Project	IEEE 802.16 Broadband Wireless Access Working Group < http://ieee802.org/16 >	
Title	HO Latency Reduction	
Date Submitted	2008-05-15	
Source(s)	Brian Shim, Sungjin Lee, Geunhwi Lim, Samsung Electronics Xiangying Yang Intel Vladimir Yanover, Nadav Lavi Alvarion Tzavidas Stavros Motorola Kiseon Ryu LGE Yerang Hur Posdata	Voice: +82-31-279-5248 E-mail: steve.lee@samsung.com E-mail: xiangying.yang@intel.com E-mail : vladimir.yanover@alvarion.com E-mail : stavros.tzavidas@motorola.com E-mail : ksryu@lge.com E-mail : yehur@posdata-usa.com
Re:	LB26c	
Abstract	This proposal proposes a method to reduce handover latency.	
Purpose	Review and adopt.	
Notice	<i>This document does not represent the agreed views of the IEEE 802.16 Working Group or any of its subgroups. It represents only the views of the participants listed in the "Source(s)" field above. It is offered as a basis for discussion. It is not binding on the contributor(s), who reserve(s) the right to add, amend or withdraw material contained herein.</i>

Handover Latency Reduction

Figure A - Seamless HO call flow

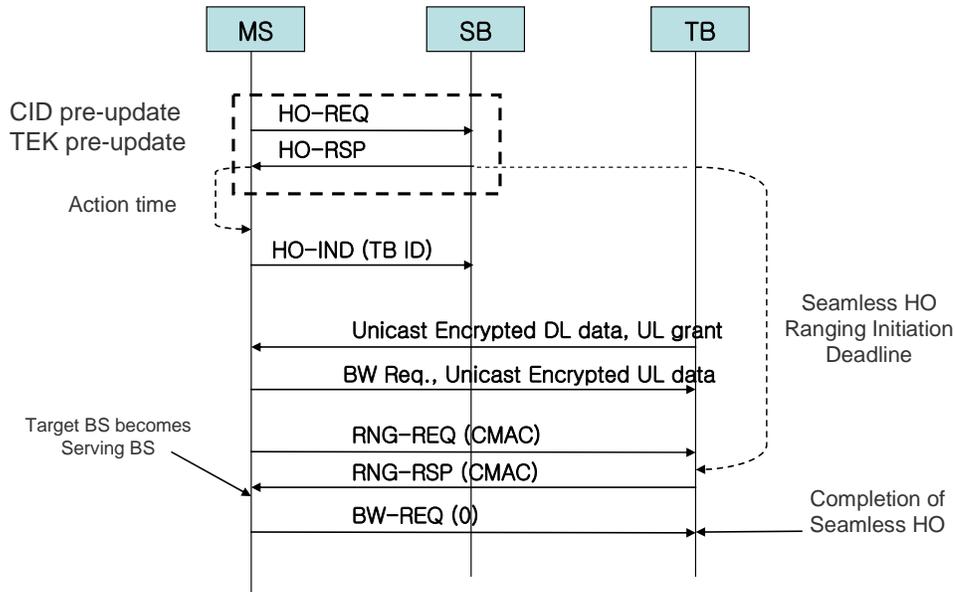
During seamless HO, the target BS (T-BS) may allocate downlink and uplink resource for the MS before the RNG-REQ/RSP message transaction, as shown in figure A.

The RNG-REQ/RSP transaction for Seamless HO is shown in Figure A. MS shall initiate RNG-REQ/RSP transaction by transmitting RNG-REQ message to target BS before the deadline specified by the “Seamless HO Ranging Initiation Deadline” attribute included in BSHO-REQ/RSP message during handover preparation. The RNG-REQ message shall include Basic CID, CMAC KEY COUNT and valid HMAC/CMAC tuple. Ranging Purpose Indication TLV with Bit #2 set to 1, but not include MS MAC address or previous serving BS-ID. When BS receives the RNG-REQ message, BS shall respond to the RNG-REQ message by transmitting RNG-RSP message with valid HMAC/CMAC tuple. The RNG-RSP message shall include Basic CID but does not need to include any CID update TLV or SA-TEK-Update TLV.

When MS receives the RNG-RSP message from the target BS, the target BS becomes serving BS of the MS and MS shall transmit a BR header with 0 bandwidth request. When BS receives the BR header, the Seamless HO procedure completes successfully.
